PRODUCT / PROCESS CHANGE NOTIFICATION

PCN-000753

TS13401ULTRT

Additional Source to Support Production Assembly and Final Test from Carsem Suzhou to Carsem Malaysia

SEMTECH Package Outline on TS13401IULTRT CarsemSZ (Old) and CarsemIPH (New)

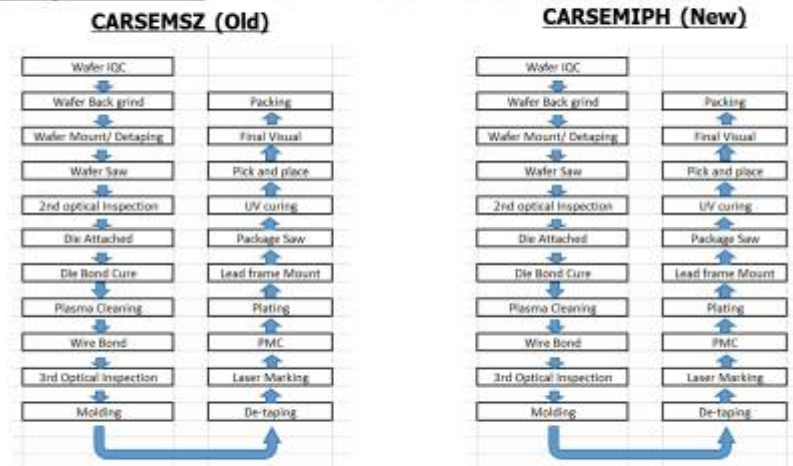
No Change in Package Outline.

BOM Comparison CarsemSZ (Old) vs CarsemIPH (New) for TS13401IULTRT

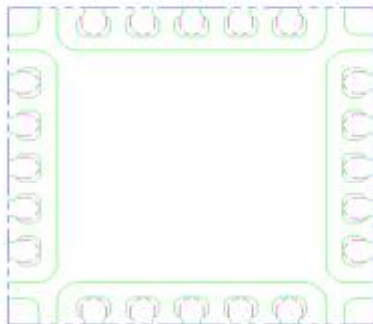
- BOM for both supplier CarsemSZ and CarsemIPH are no difference.

**Bonding Layout (CarsemSZ vs
CarsemIPH) for TS13401IULTRT**

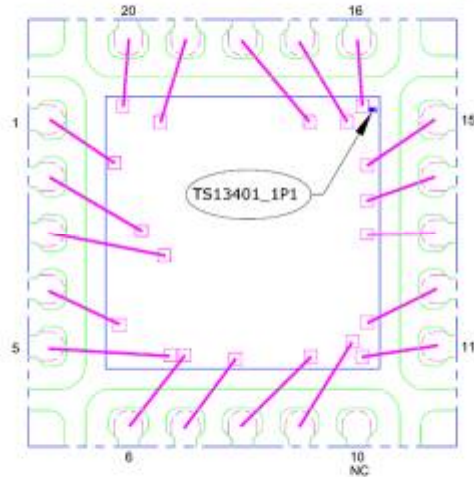
No Change in Bonding Layout.
